Subject: The Pinnacle Club Condos, Phase 1, 2, & 3
Response Letter

In response to the comments regarding the Pinnacle Club Condos, Phases 1, 2, & 3, the appropriate modifications have been made to the Development Plan and Engineering Plan. The following remarks clarify comments raised in your February 2nd review letter.

THE PINNACLE CLUB CONDOS PHASE 1, 2 & 3

CITY OF GROVE CITY, OHIO
DEVELOPMENT PLAN
FOR
**THE PINNACLE CLUB CONDOS
PHASE 1, 2 & 3**
UTILITY PLAN

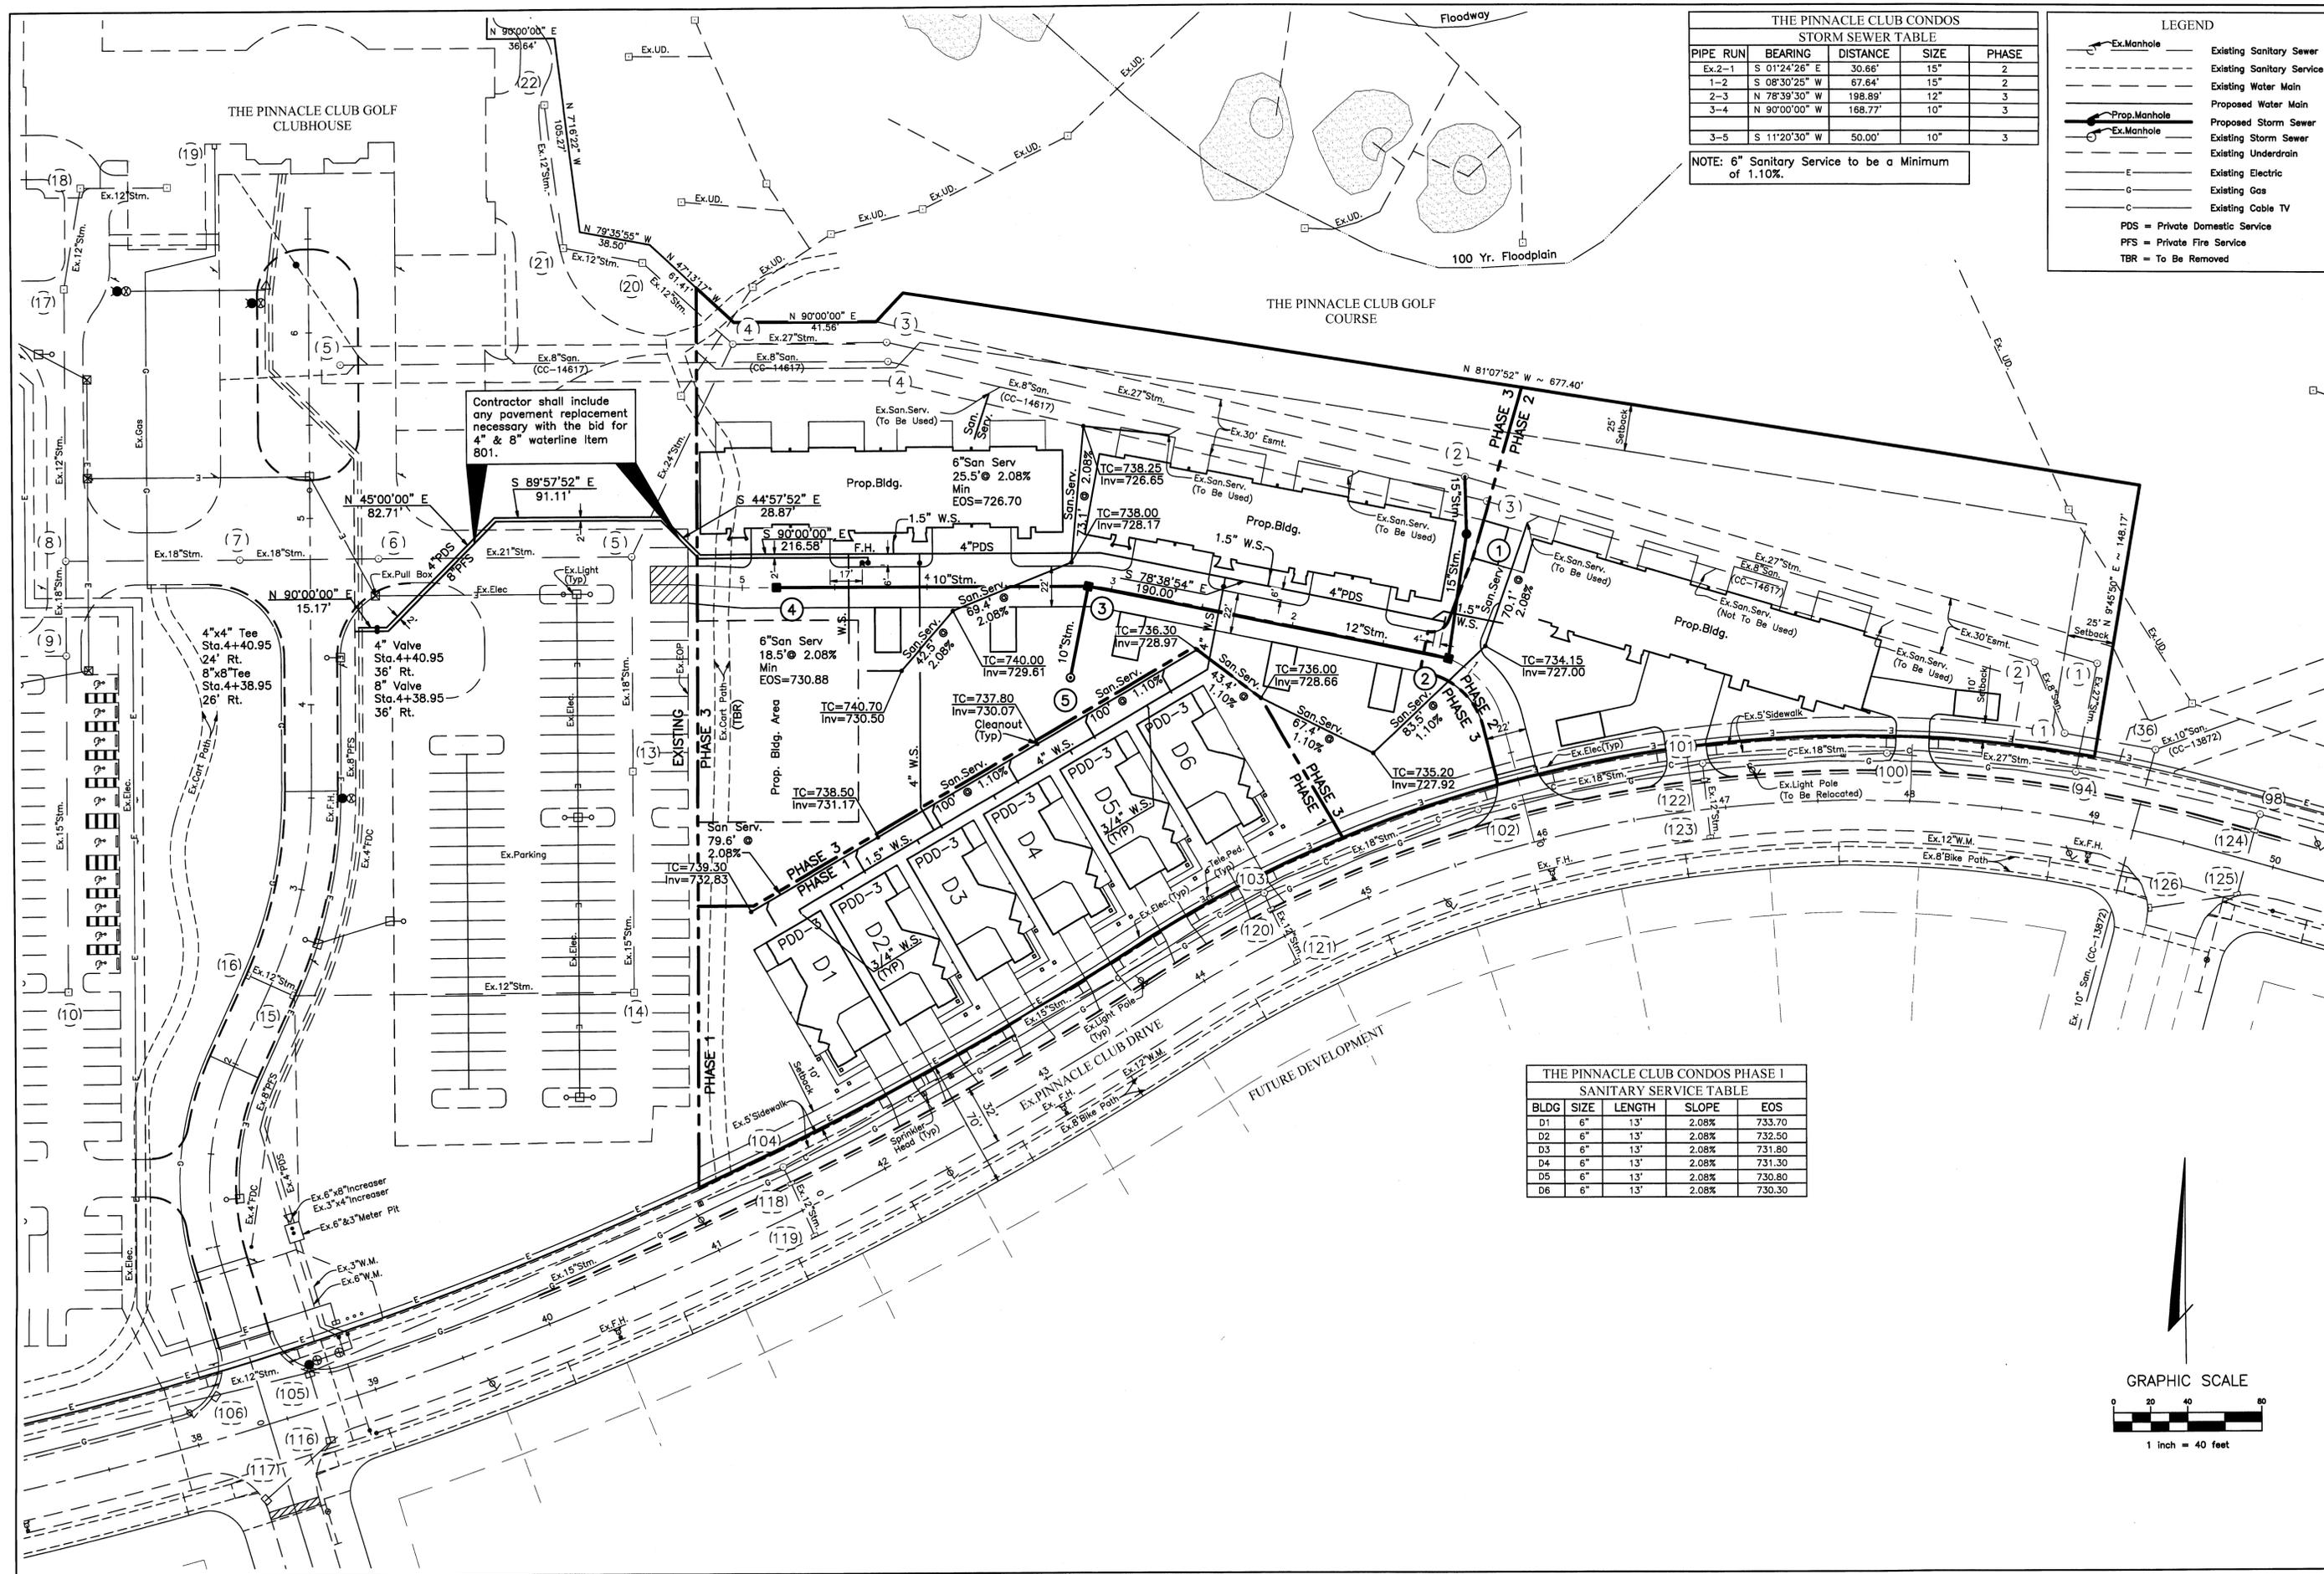
19. The fire line has been increased to an 8" line as requested. The plans have been modified accordingly.
20. Please see the Landscape/Signage Plan prepared and provided by Ciminello's, Inc. for the location of the "No Parking Fire Lane" signs.

CITY OF GROVE CITY, OHIO
 DEVELOPMENT PLAN
 FOR
**THE PINNACLE CLUB CONDOS
 PHASE 1, 2 & 3**
 SITE, DIMENSIONAL & SIGNAGE PLAN

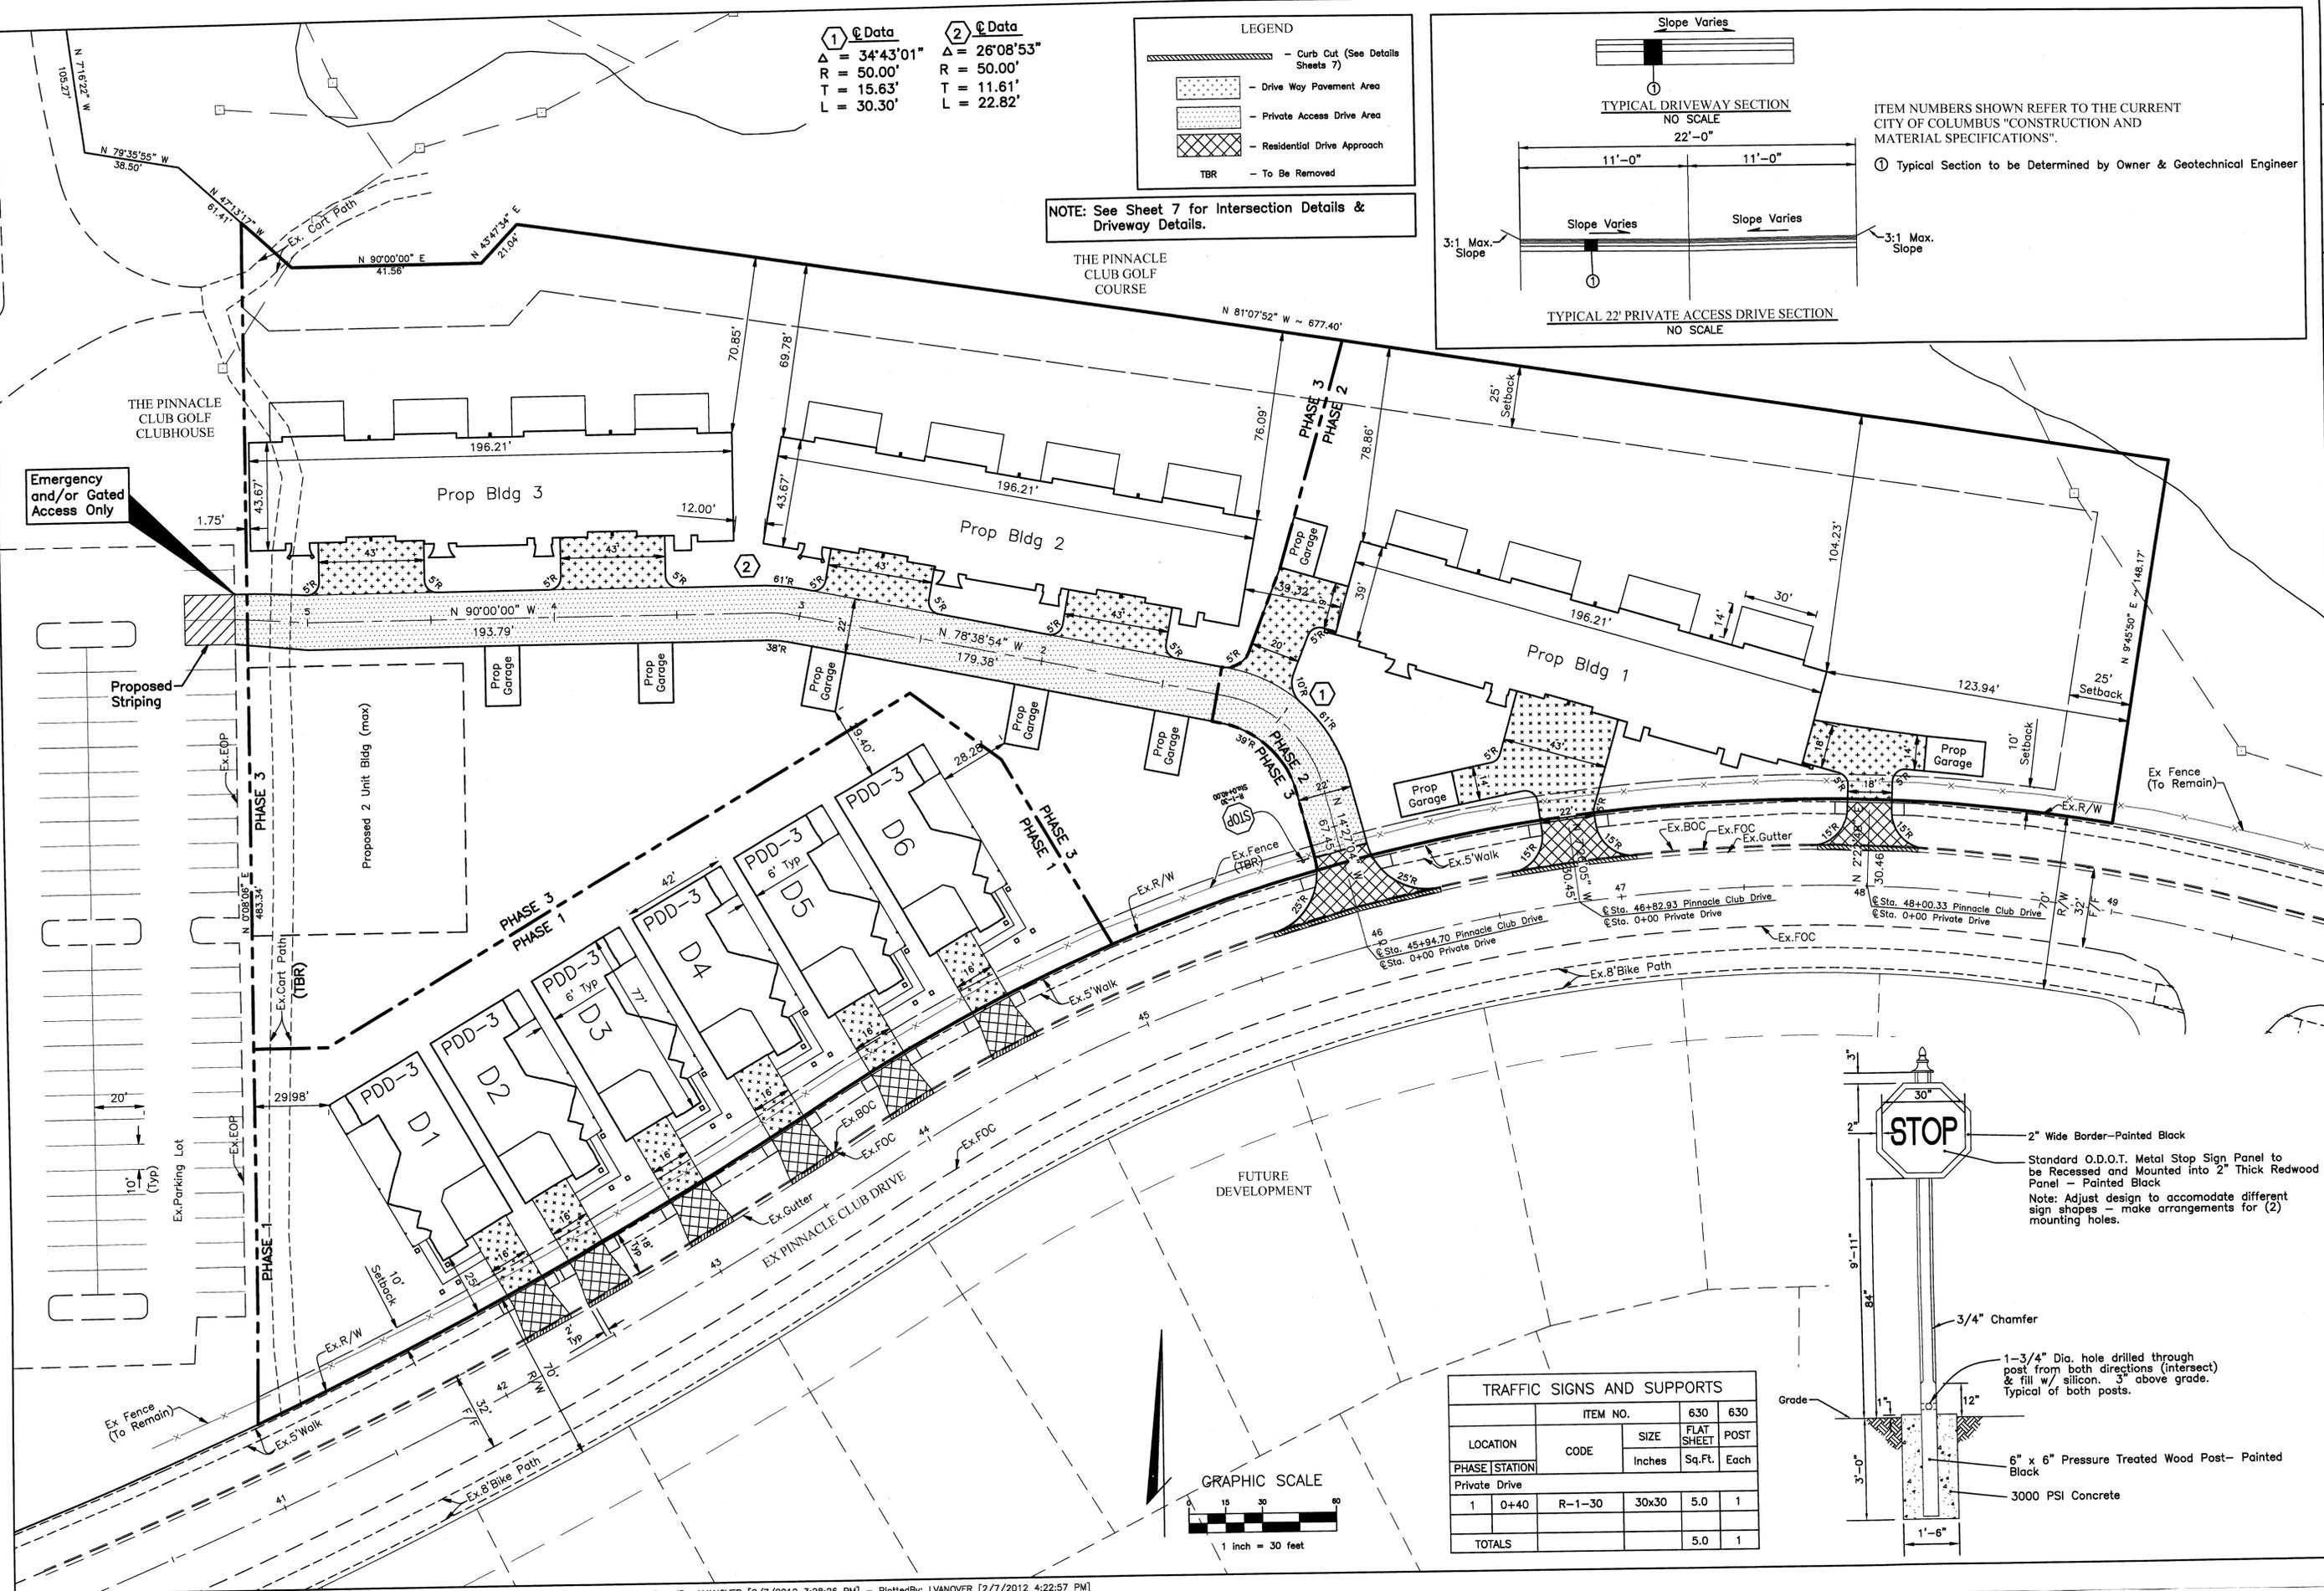
5. The street trees to be removed as part of this development will be shown on the Landscape Plan.
6. Proposed setbacks have been shown and labeled on the plans as requested.

9. The driveway curb cut for units 2 and 3 has been reduced to 22' wide as requested. The plan details have been modified accordingly.
10. A list of the standard construction drawings is located on the title sheet of the Engineering Plans.
11. The existing trail is to be removed. The plans have been modified for clarification.
12. Upon Development Plan approval the lots will be split and combined as shown on the enclosed survey exhibits.
13. Units 1-12 shall have the same materials as the clubhouse. Units D1-D6 shall have materials compatible to the clubhouse. Please see enclosed material specification list.
